ADDENDUM No. 1  
TO THE  
CONTRACT DOCUMENTS FOR CONSTRUCTION OF  
BRADFORD AVENUE RAMP REPLACEMENT  
PROJECT #24PW07

ISSUED THIS 28<sup>th</sup> DAY OF MARCH, 2024.

CITY OF ROSEBURG  
PUBLIC WORKS DEPARTMENT  
900 SE DOUGLAS AVENUE  
ROSEBURG, OREGON 97470  
(541) 492-6730

No. PW-009

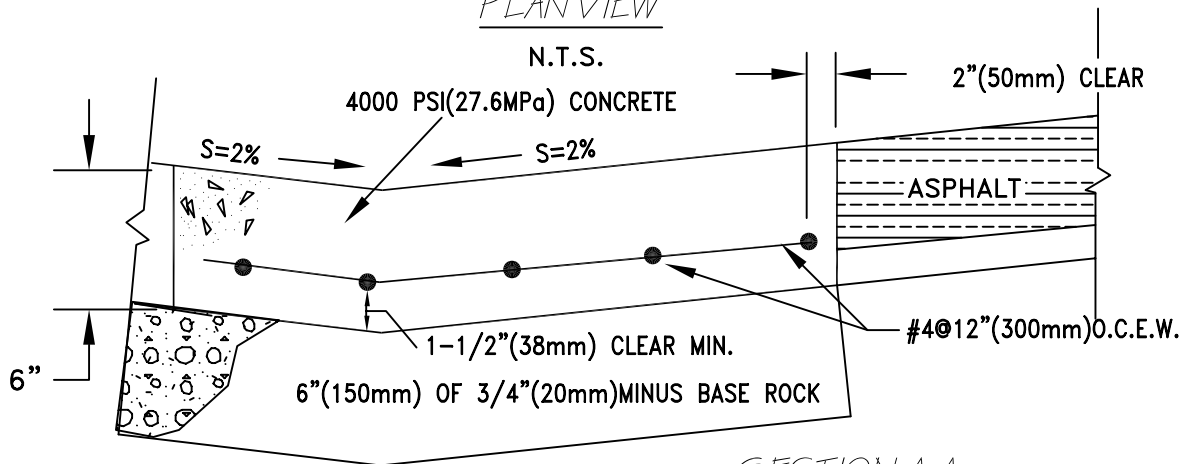
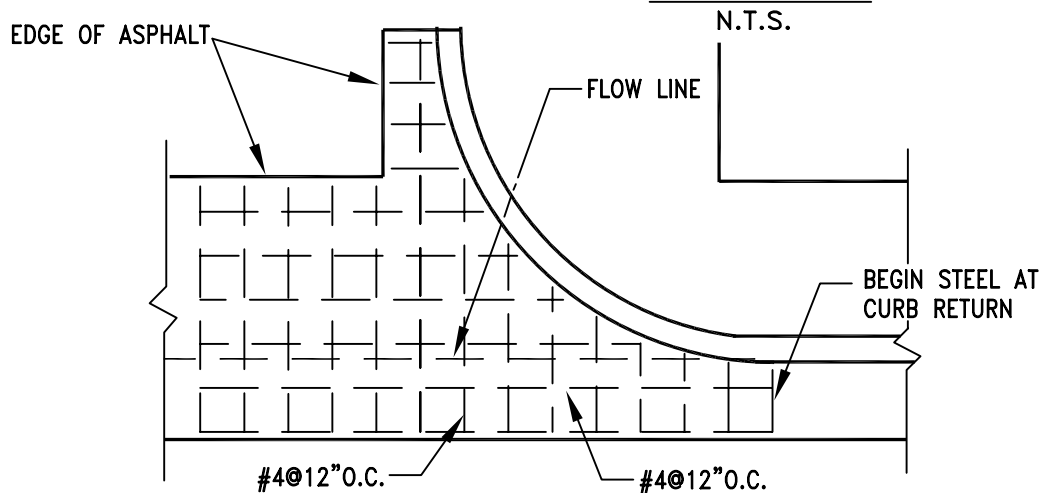
**Question #2:** What's the Valley Gutter thickness, and what is it billed under?

**Response:** Valley Gutter is 6" thick. Please see attached COR Detail (PW-009). Payment is under Bid Items A-12 & B-5.

1. PW-009
